PLAN COMMISSION MEETING AGENDA

**TUESDAY, January 28, 2014
AT 6:00 P.M.**

MINUTES OF THE
OAK CREEK PLAN COMMISSION MEETING
TUESDAY, January 14, 2014

1 SITE PLAN
 Scale: 1"=20'-0"

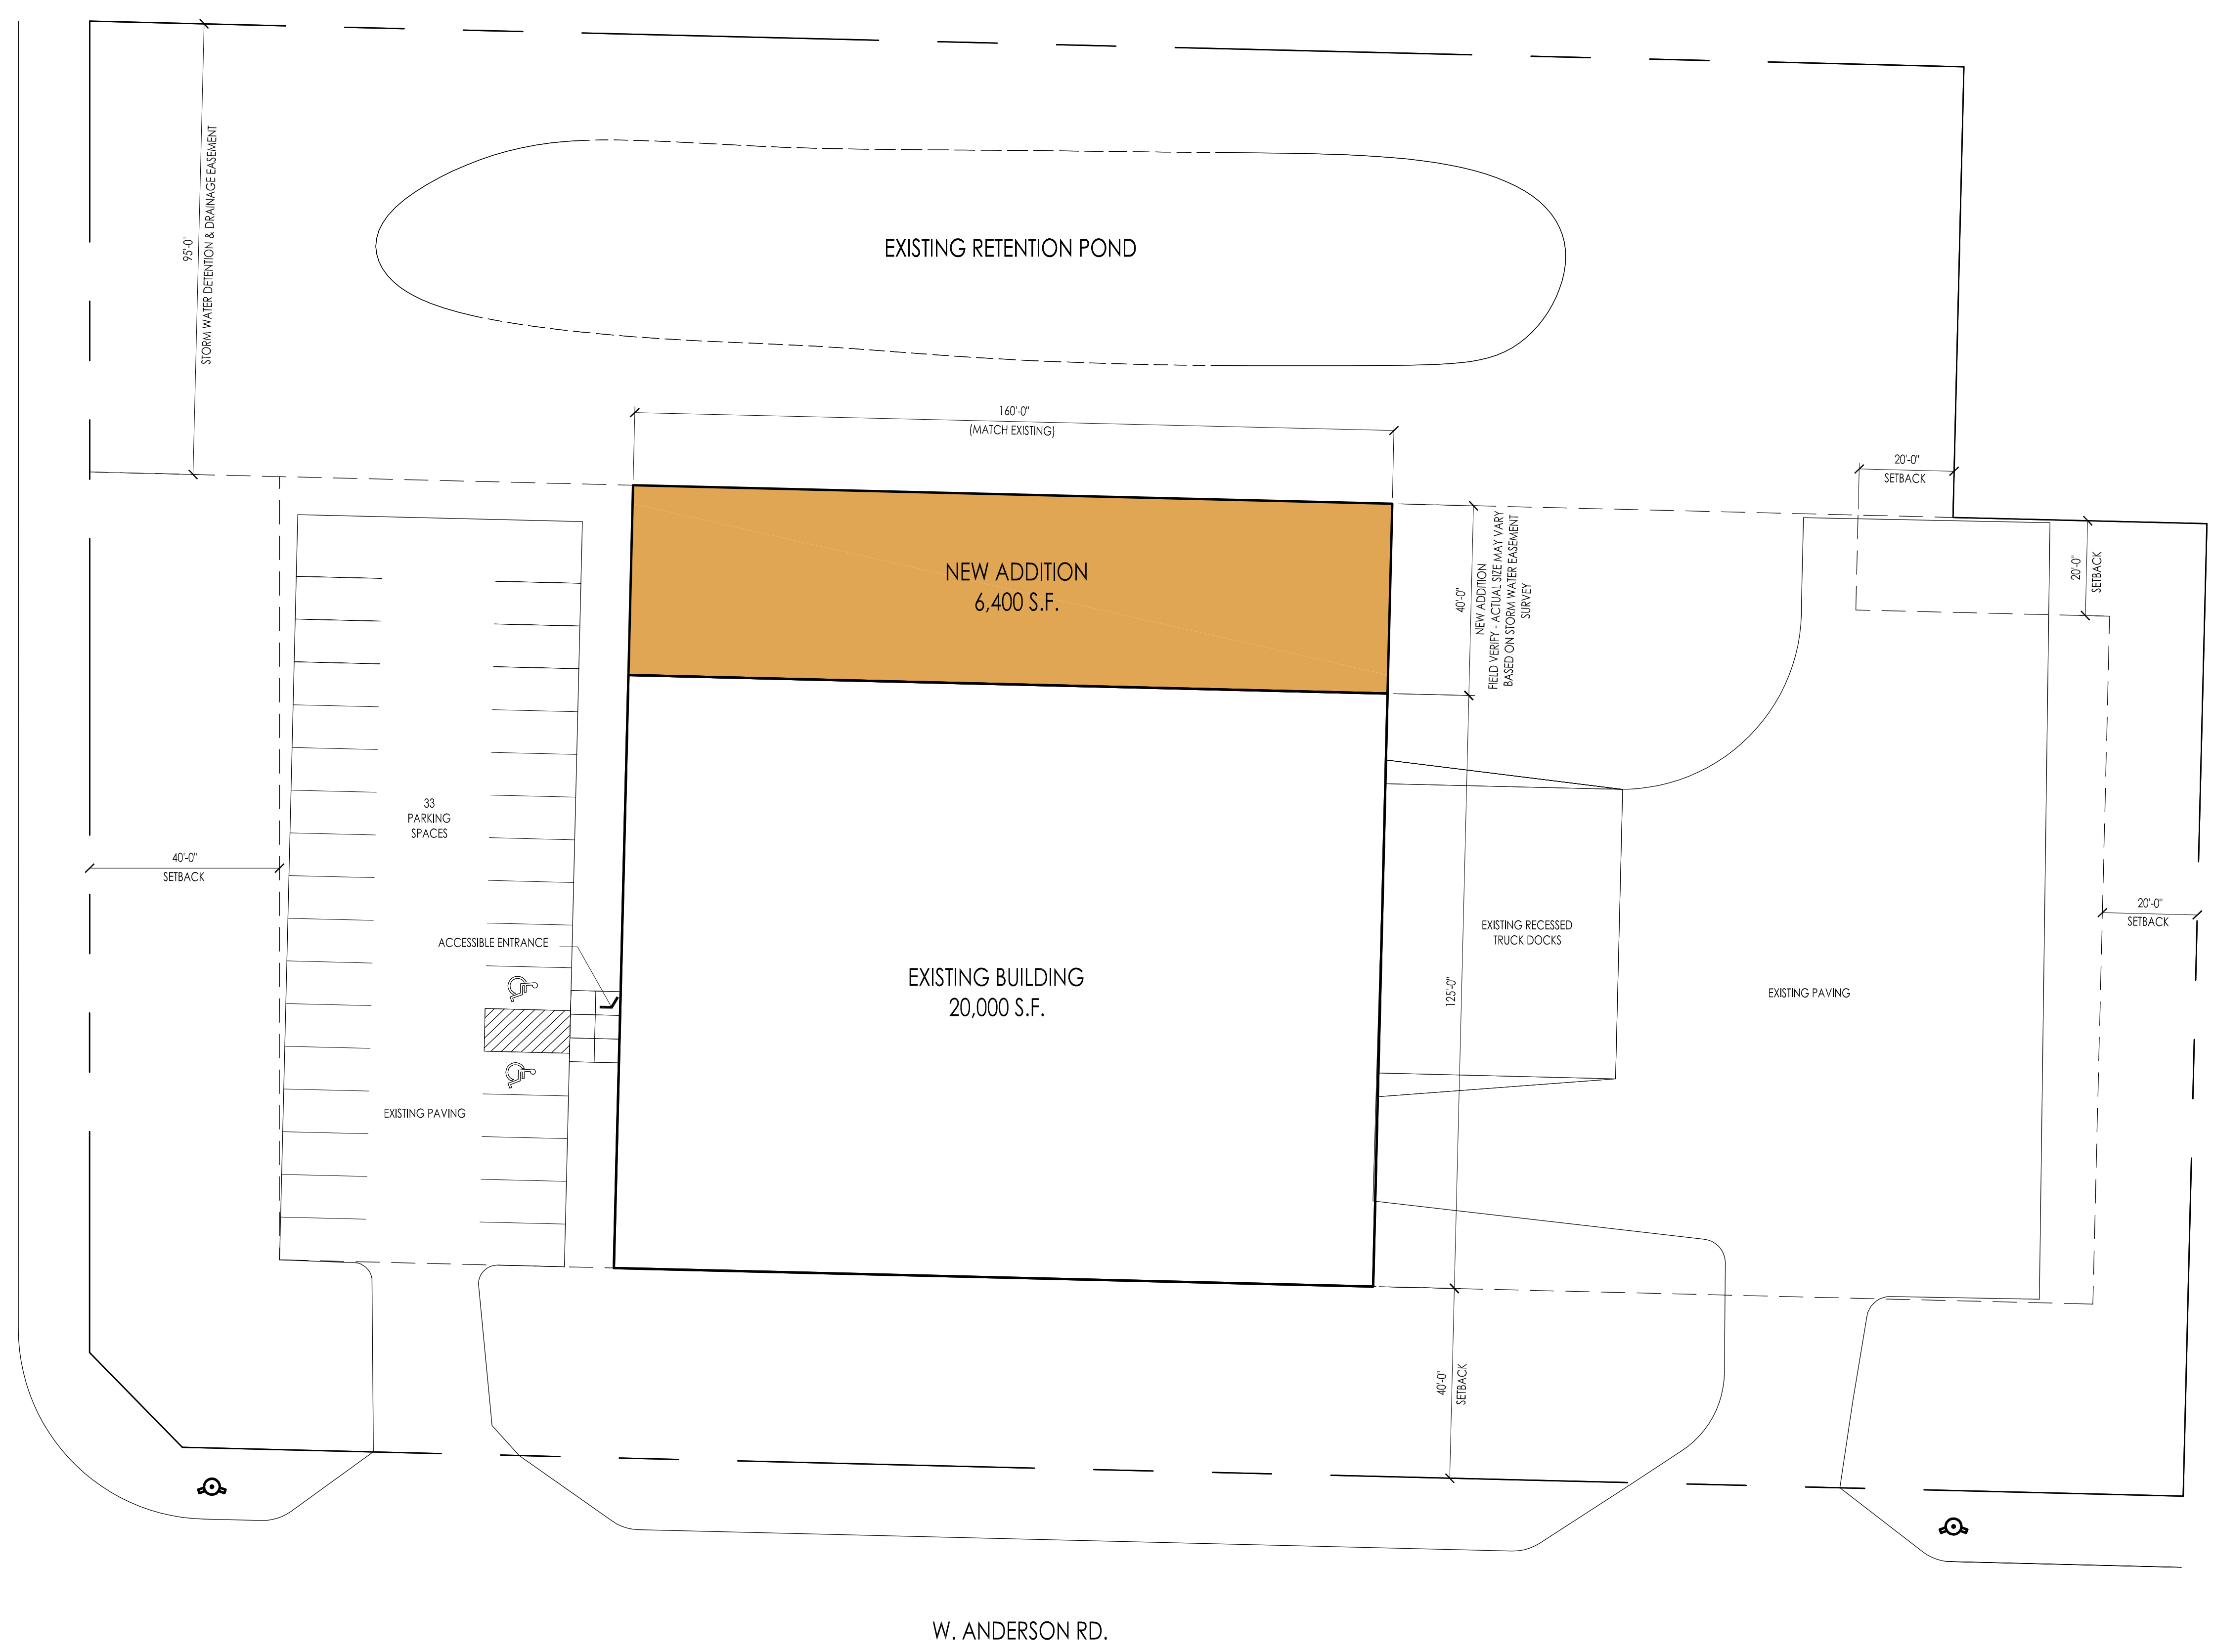
As proposed, the location of the addition meets all required setbacks. However, there is one footing noted on the plans that encroaches into the stormwater easement. The Applicant has indicated that the plans will be revised such that the building and footings are sited entirely outside of that easement. The building size may change slightly to accommodate this revision. Lot coverage is estimated to be approximately 43% following construction.

1 EAST ELEVATION
 Scale:

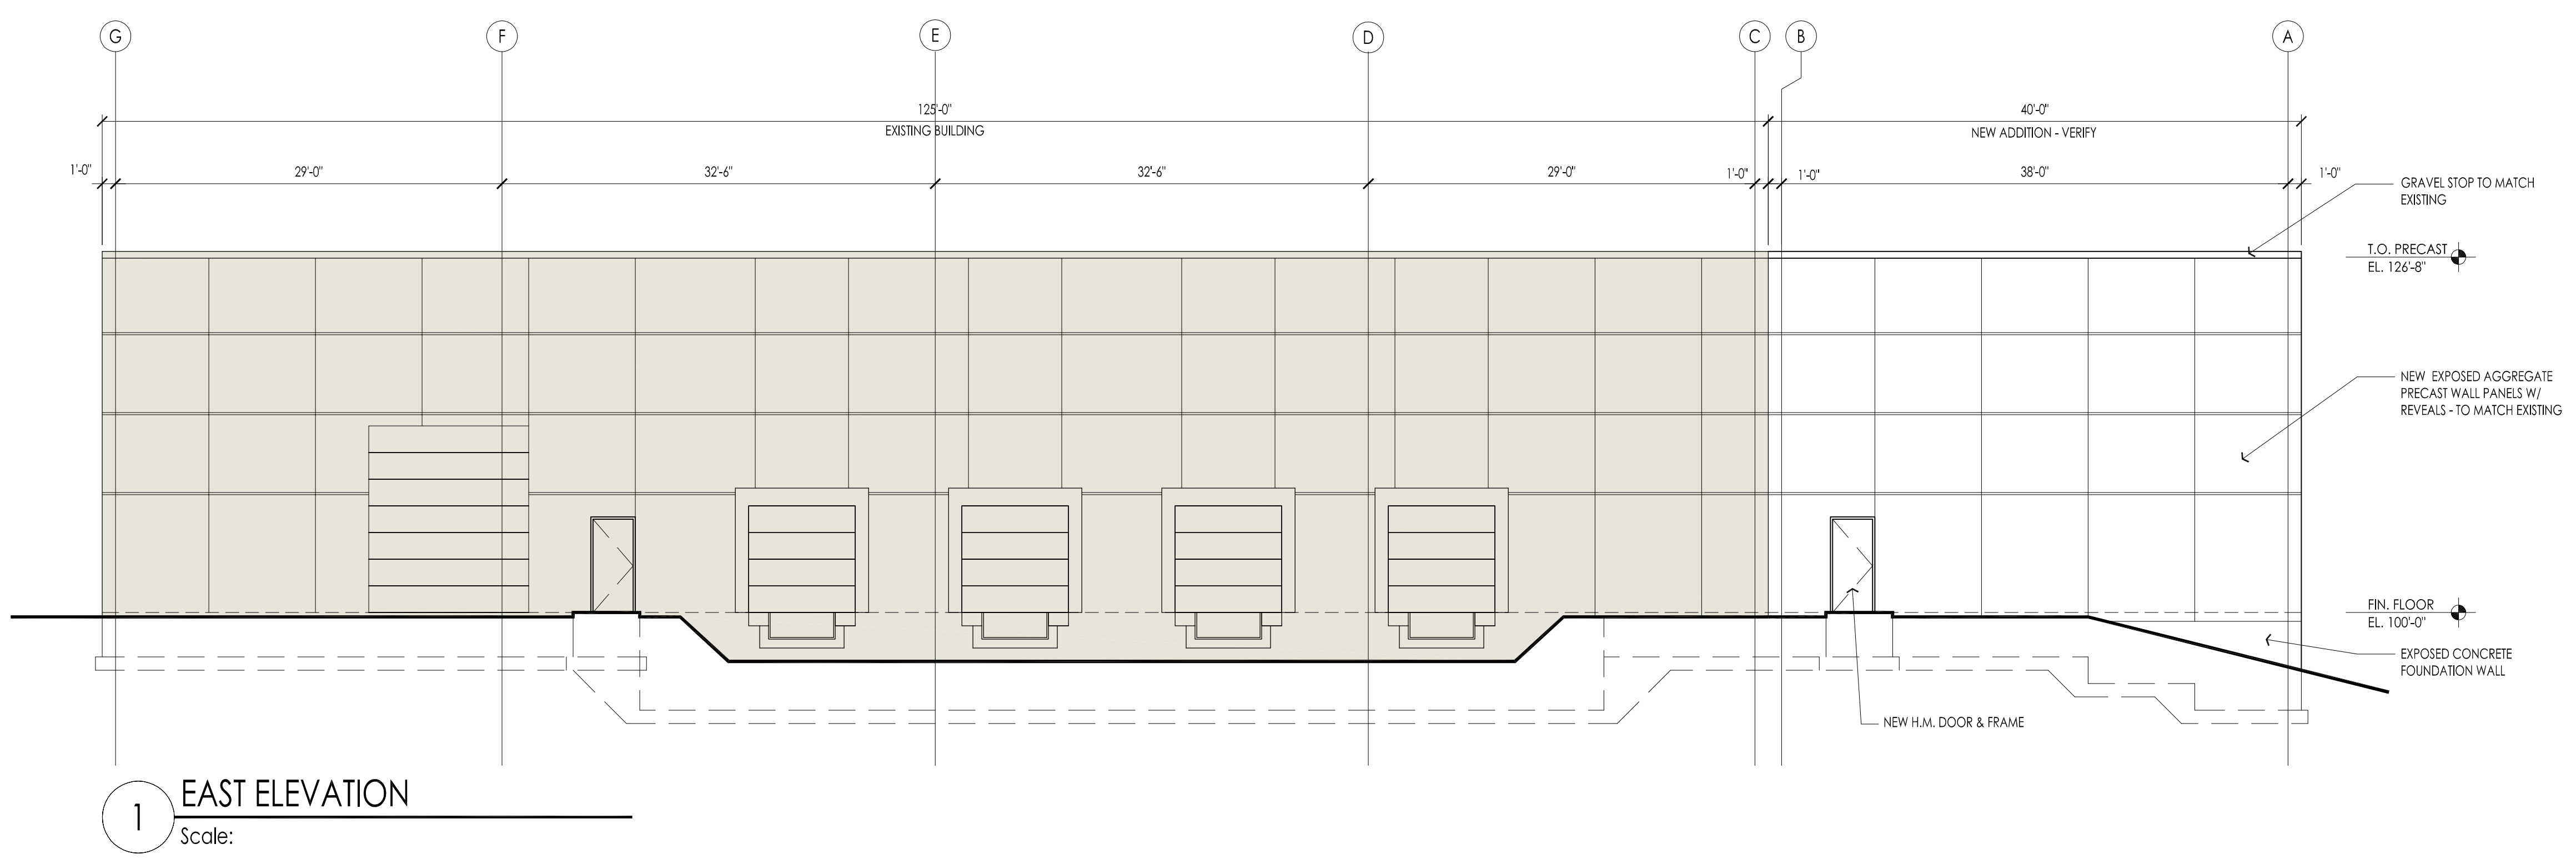
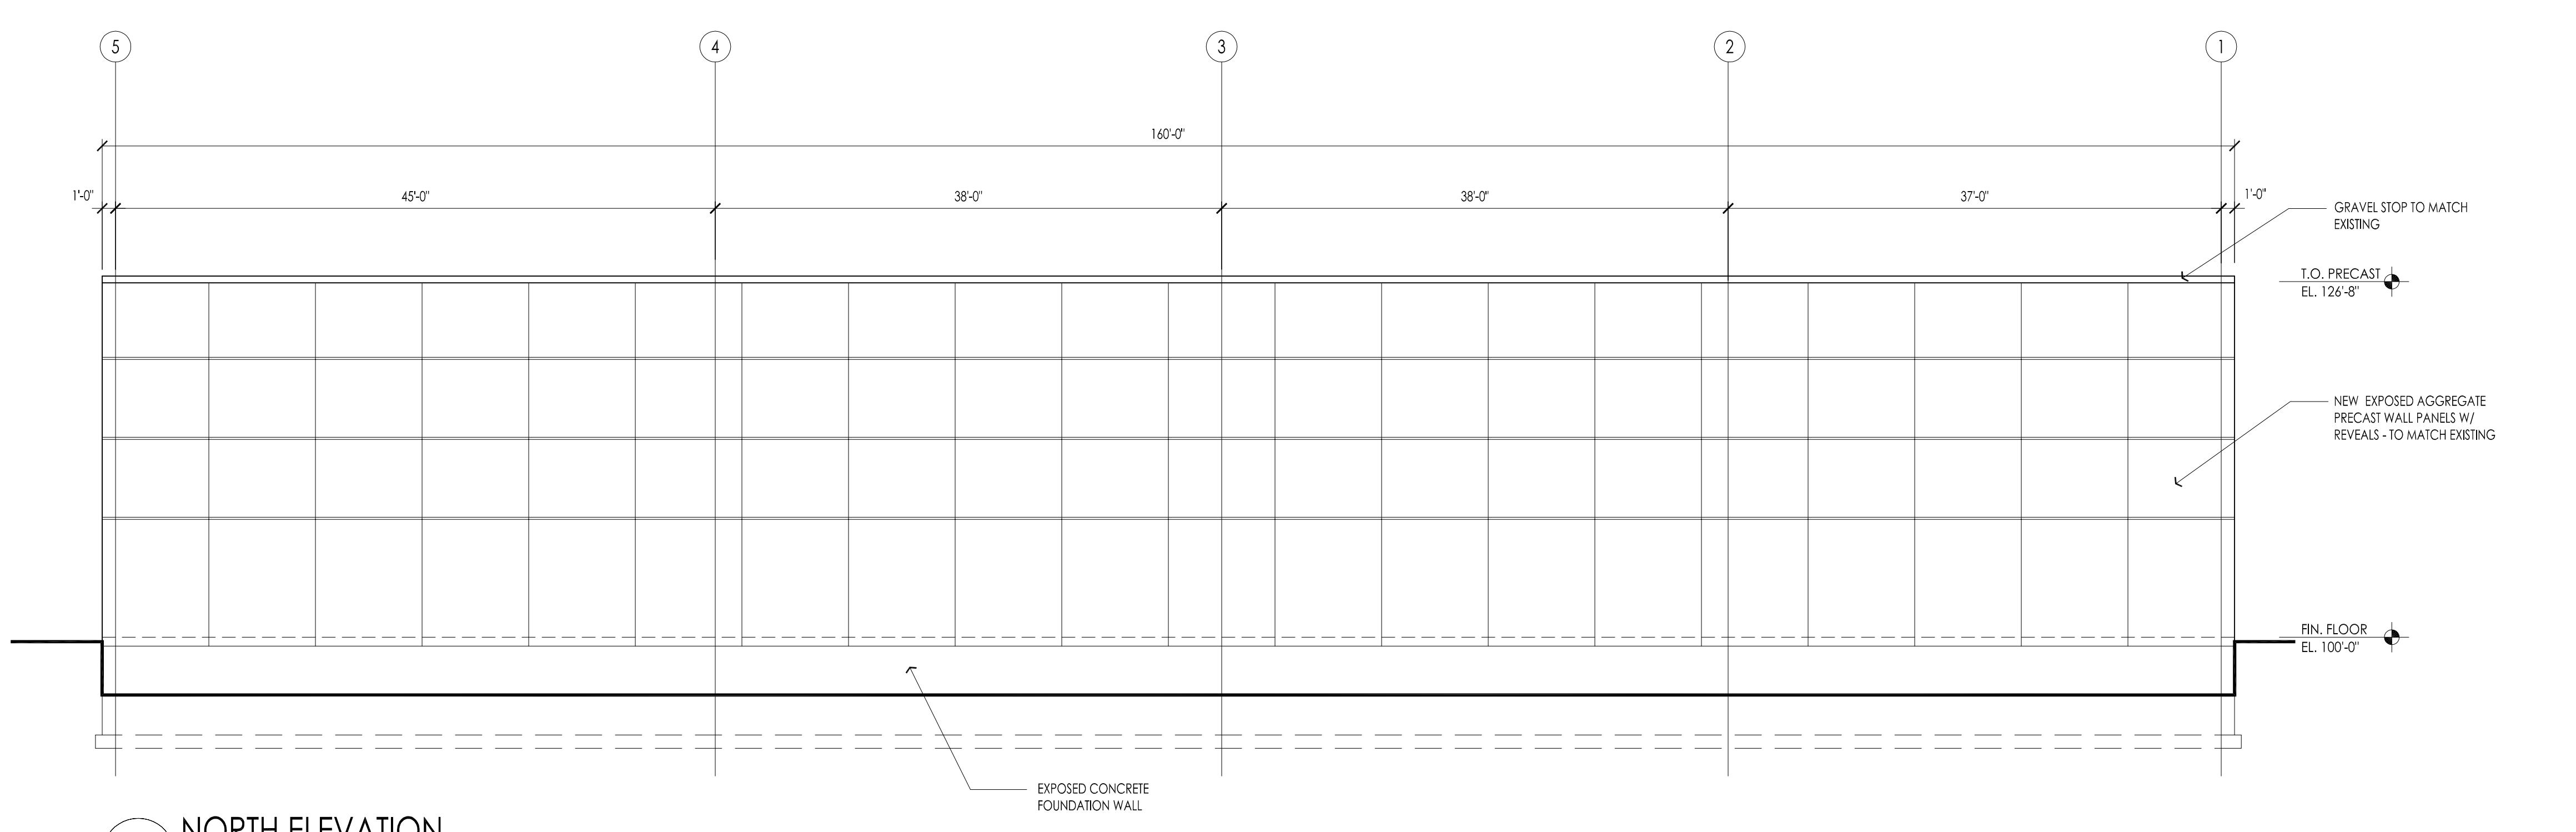
The addition will be constructed with exposed aggregate precast wall panels to match the existing building. While the panels are acceptable building materials, Section 17.1009(a)(6) requires facades measuring 100 feet or longer to incorporate details to “break up” the length of the façade. However, staff recognizes that the proposed use is warehouse storage, and that the existing building does not include such articulations. The Plan Commission may modify the standards in this section of the Code by $\frac{3}{4}$ majority vote.
